**CITY OF PORTLAND, MAINE
DEVELOPMENT REVIEW APPLICATION
PLANNING DEPARTMENT PROCESSING FORM**

3/10/00
Application Date
Milton Street Subdivision
Project Name/Description

Gorrill-Palmer Consulting Engineers, Inc. has received a copy of the memorandum to Rick Knowland from DeLuca-Hoffman Associates, Inc., dated August 24, 1999, regarding comments concerning the above referenced project and has prepared responses to each of their comments. For your convenience, each of his comments is repeated followed by our response.

Gorrill-Palmer Consulting Engineers, Inc. has received a copy of the memorandum to Rick Knowland from Anthony Lombardo P.E., Project Engineer, Public Works Department dated January 3, 2000, regarding comments concerning the above referenced project and has prepared responses to each of their comments. For your convenience, each of his comments is repeated followed by our response.

PLAN SHOWING A PORTION OF:
WOODFORDS GARDENS
PORTLAND, MAINE
PREPARED FOR RECORD OWNER:
DIVERSIFIED PROPERTIES, INC.
P.O. BOX 1027
PORTLAND, MAINE 04104

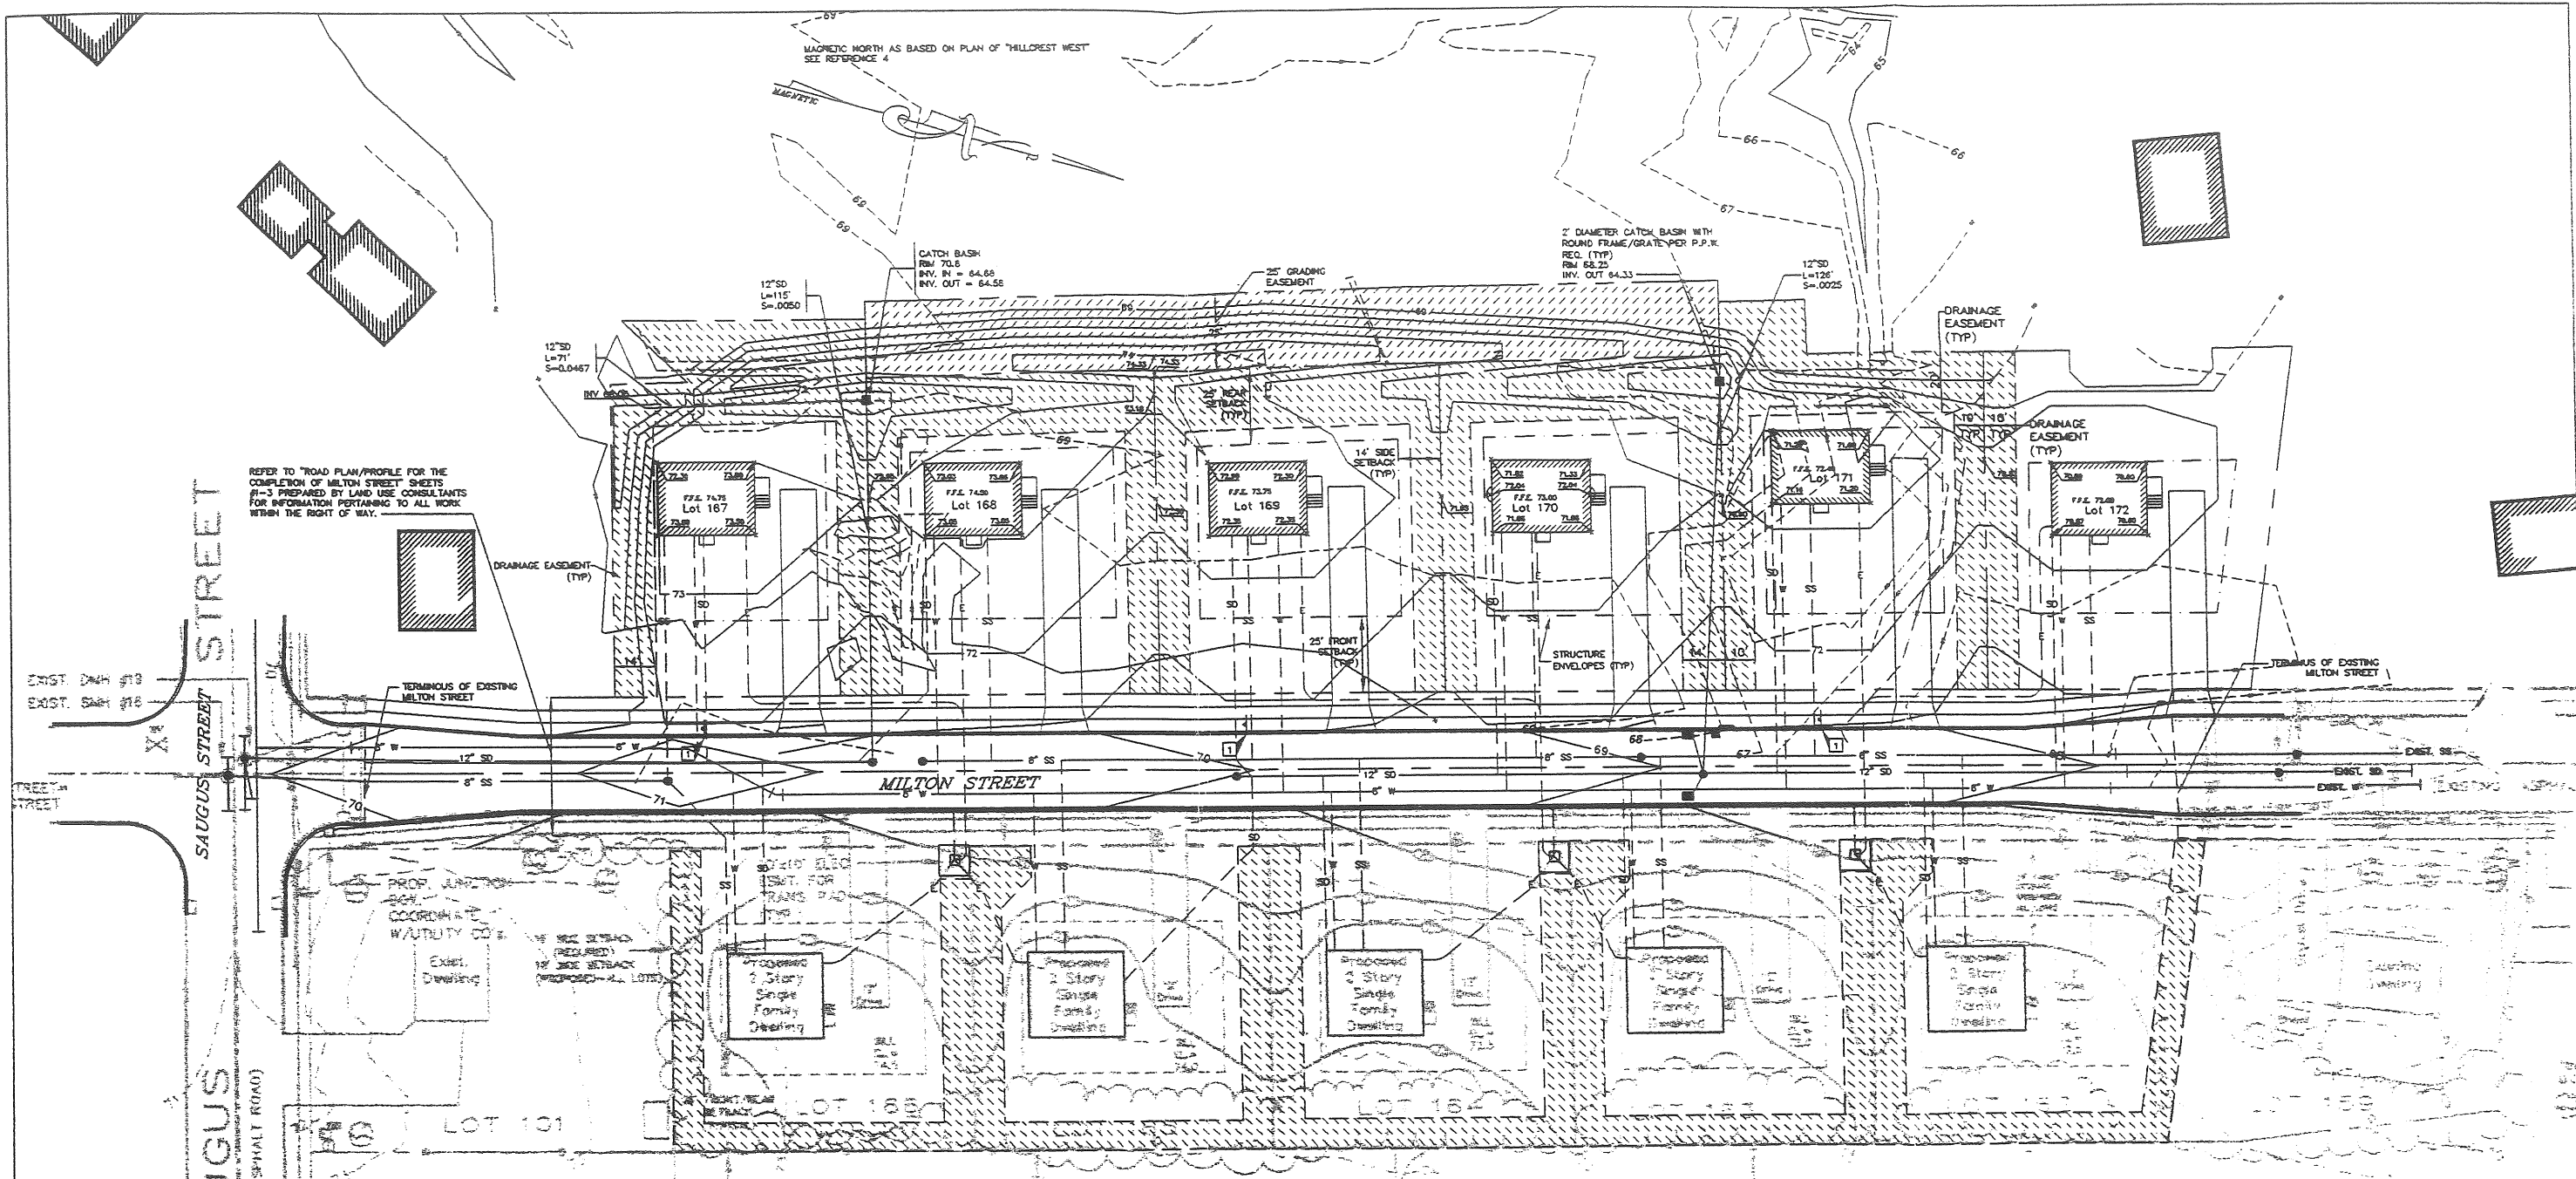
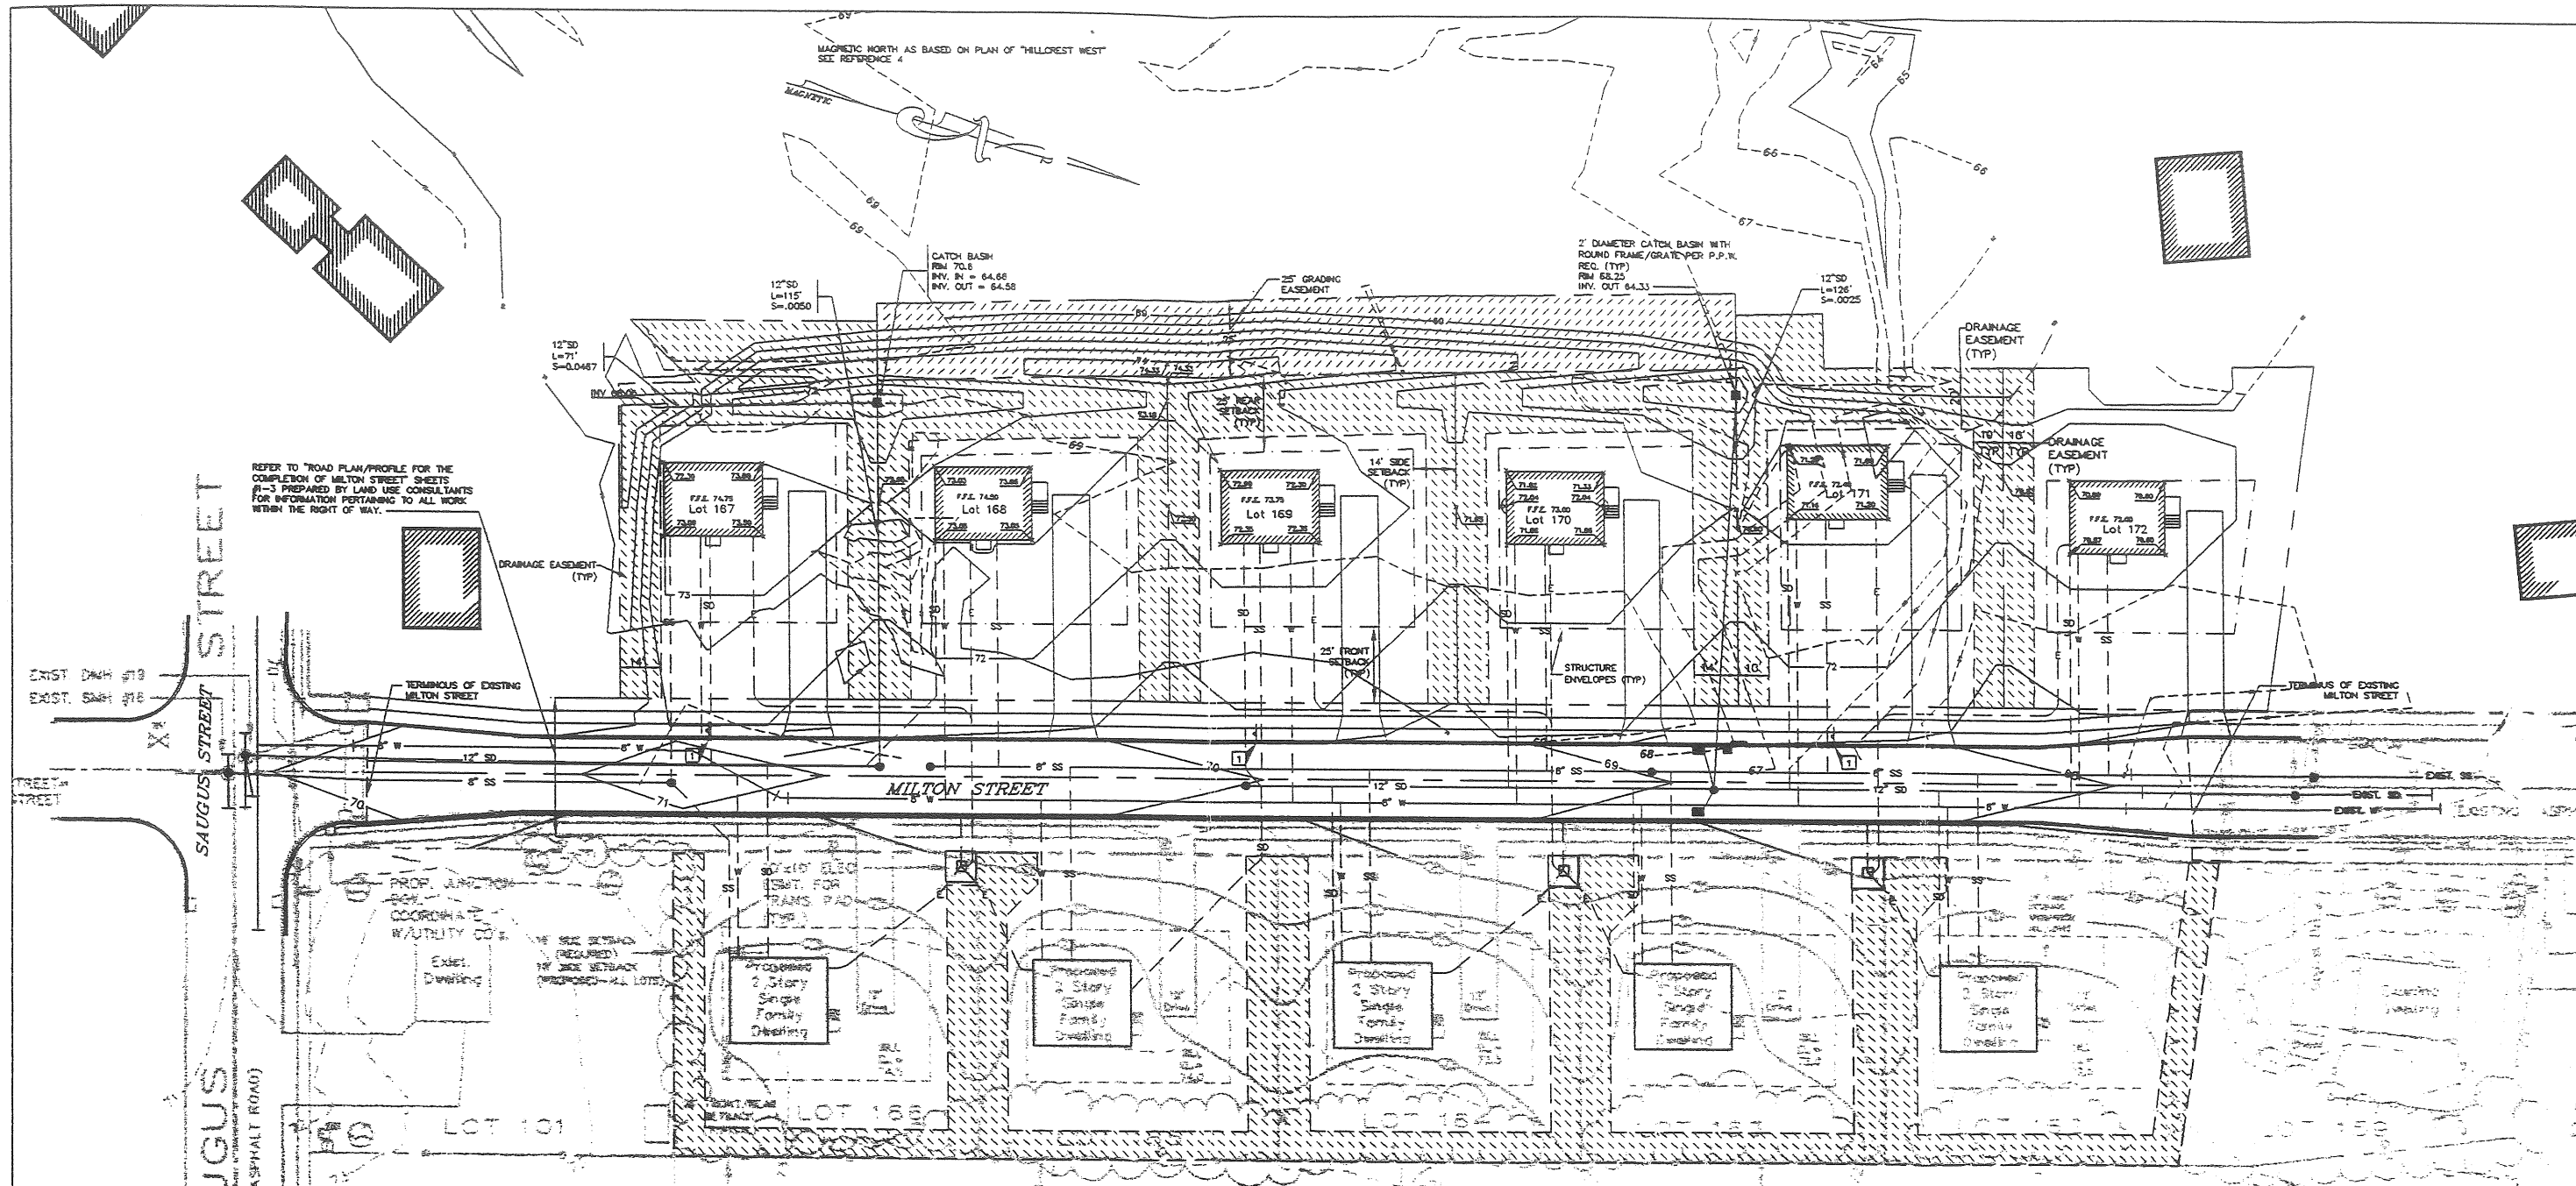
Comment 1 - The subdivision plat by Titcomb Associates should provide adequate reference to the entire plan set including the drawings from Gorrill-Palmer Consulting Engineers, Inc. and LUC. This is important since those plans have much of the relevant data re: topo, grading, utilities, etc.

Comment 2 - The subdivision plan shows no grading easement at the rear of the Germani property. This appears necessary based on the grading shown on the Gorrill-Palmer Consulting Engineers, Inc. plan. The differences are very minor i.e. 1sf. On three lots, probably due to computer rounding. However they should be corrected.

Comment 3 - The subdivision plan shows a wetland across lots 167, 168 & 169. What is the status of the permitting for this wetland area. Also, is the entire wetland area shown since it appears the wetland limit line does not connect upon itself?

Response –A note has been added to the Subdivision Plan.

Response –A grading easement has been added to the Subdivision plan. This land is owned by Diversified Properties as they have purchased it from Germani. The lot areas on the “Conceptual Development Plan” have been revised to be consistent with the Plat Plan.

Response – The revised recording plat includes the wetland information that was presented on a “Plan Showing a Portion of Woodfords Gardens”, dated August 5, 1993 and recorded in the Cumberland County Registry of Deeds in Plan Book 196, Page 140. Jim Wolf reviewed this with Mr. Bushey and it appeared that this satisfied his concerns. Further, a 4,300 s.f. of disturbance per lot is exempt from permitting under the MDEP regulations.

Drawing Name:	Conceptual Development Plan
Project:	MILTON STREET EXTENSION

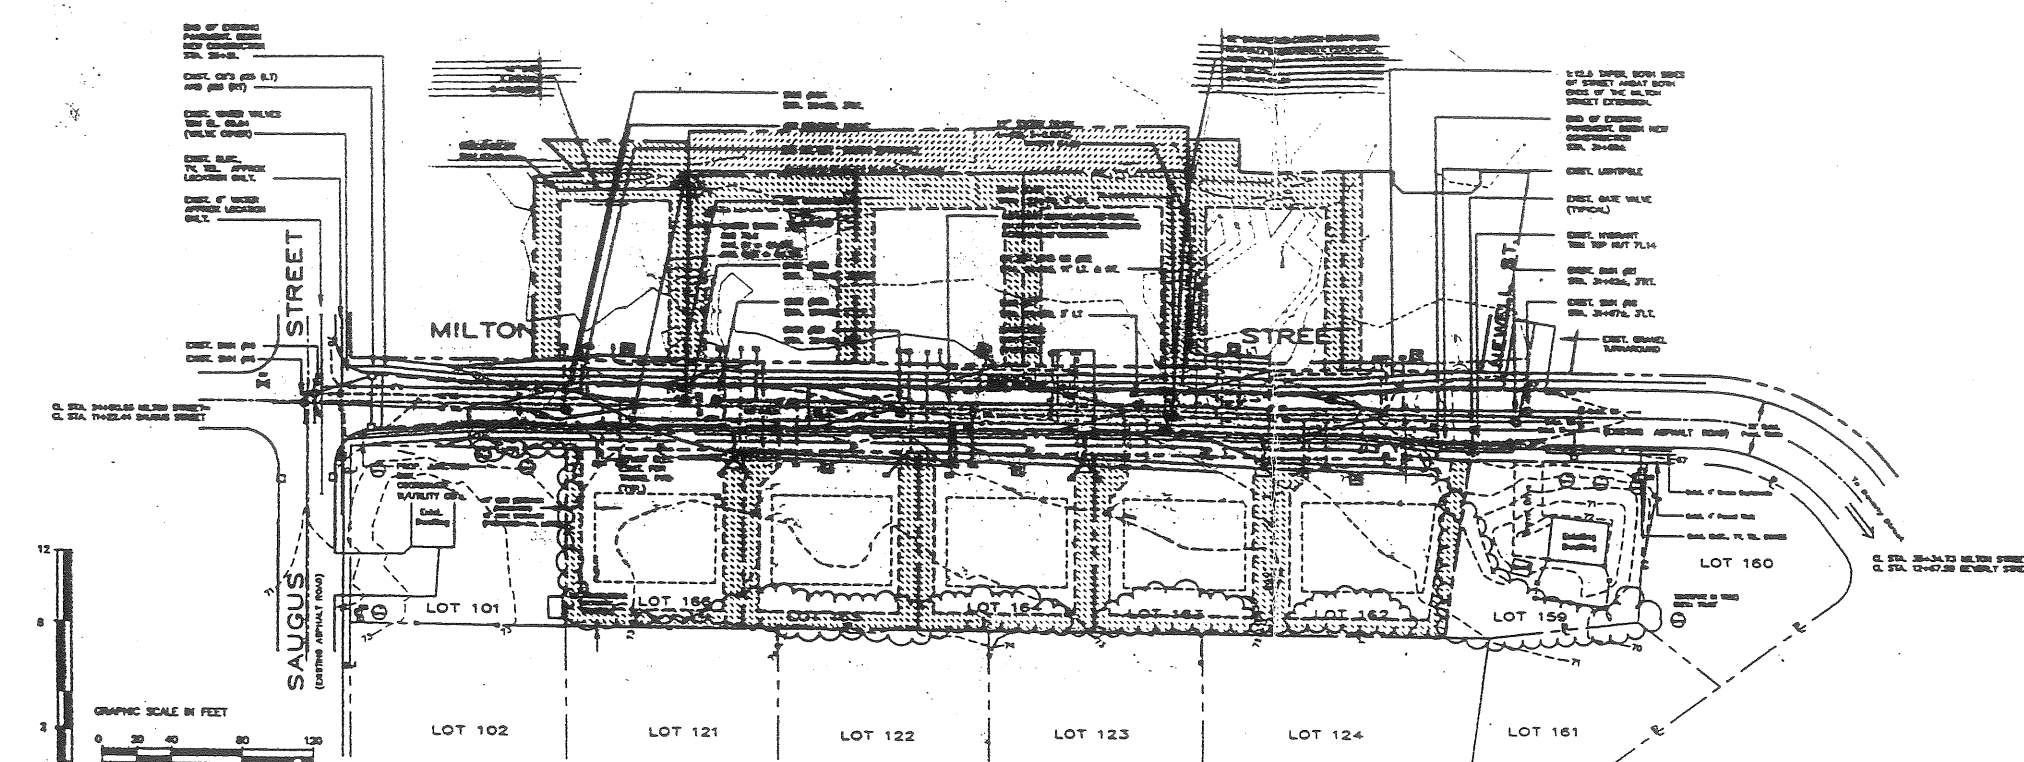
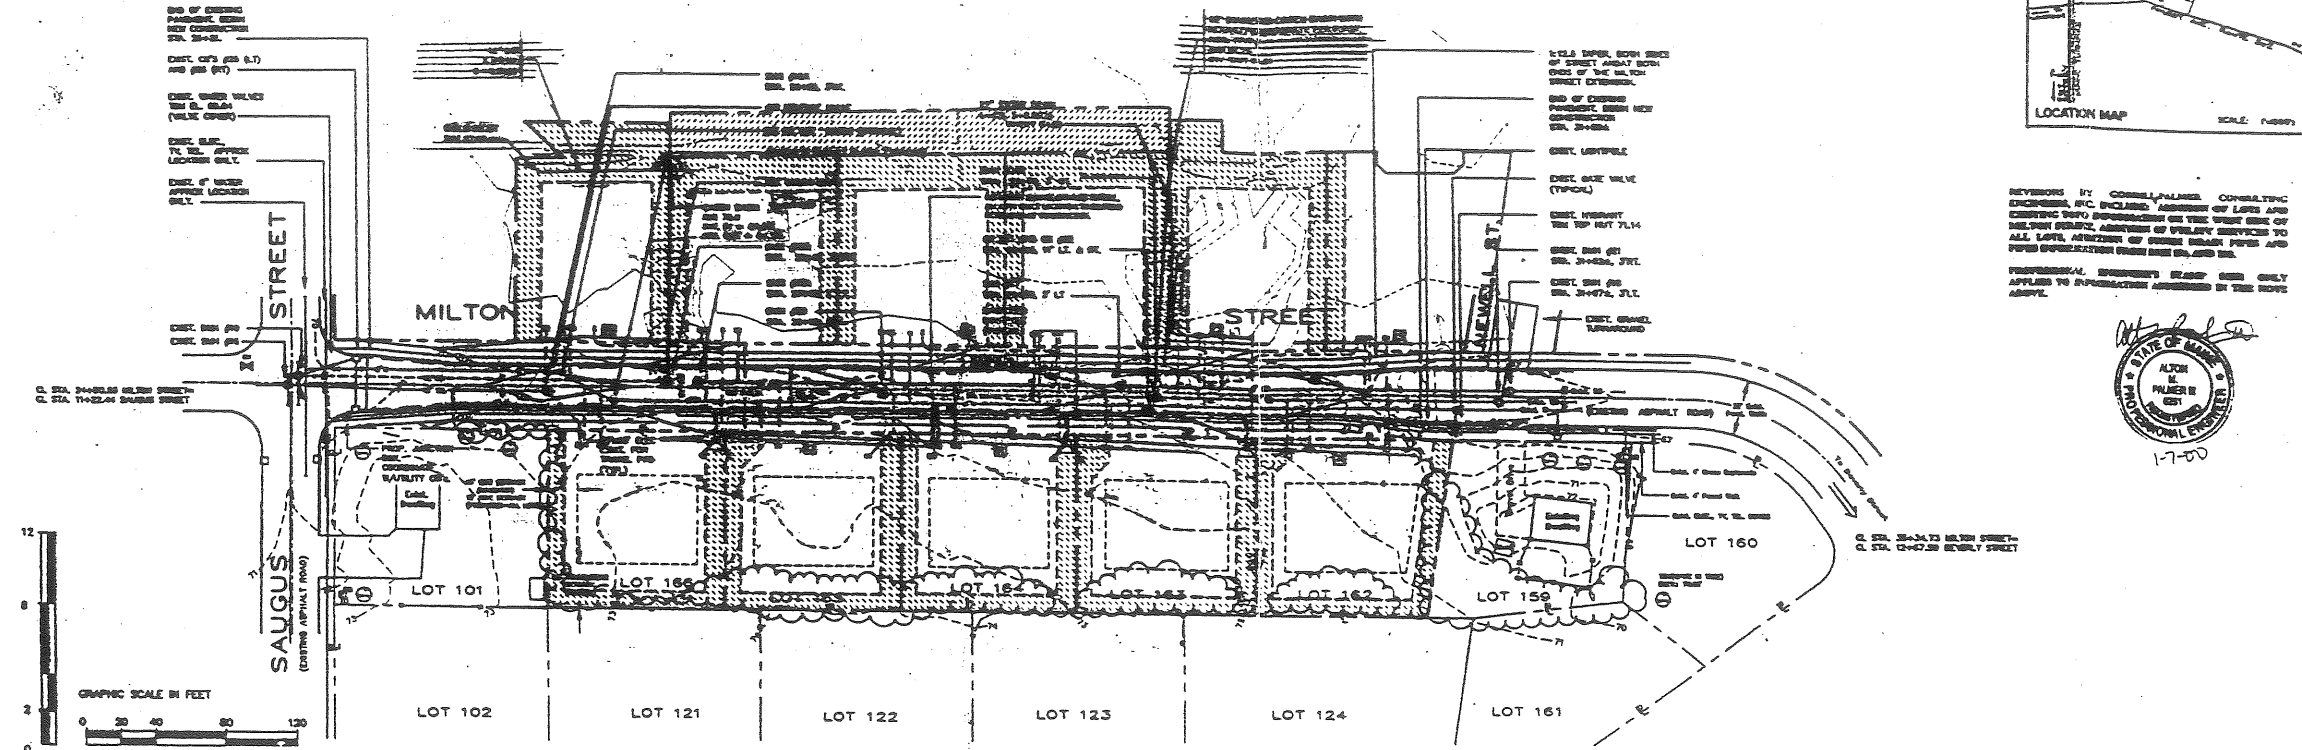
Comment 2 –The” Conceptual Plan” needs to specify invert information for the proposed catch basins located in the rear yard drainage easements.

Comment 3 –The “Conceptual Plan” also needs to specify sanitary sewer service stubs from the sanitary main for each proposed house lot. In addition, Public Works is requesting storm drain service stubs be specified for each lot so that the foundation drains for each home can be connected into the storm sewer proposed in Milton Street.

Comment 1 – Proposed Lots 165, 168 & 169 specify storm drain service connections directly into manhole structures. This appears on Sheet 5 “Conceptual Development Plan”. Public Works does not allow individual service connections into manholes and is requesting the applicant revise the plans to specify the storm drain service from Lot 168 to connect into the storm drain proposed along the southerly boundary of this lot. The services from Lots 165 & 169 should be connected into the storm drain main, in Milton Street, just ahead of the proposed manhole.

Response – Information regarding rims and inverts on the proposed catch basins have been added to the “Conceptual Plan” as well as the “Road Plan/Profile”.

Response –The stubs have been added to the Conceptual Development Plan.
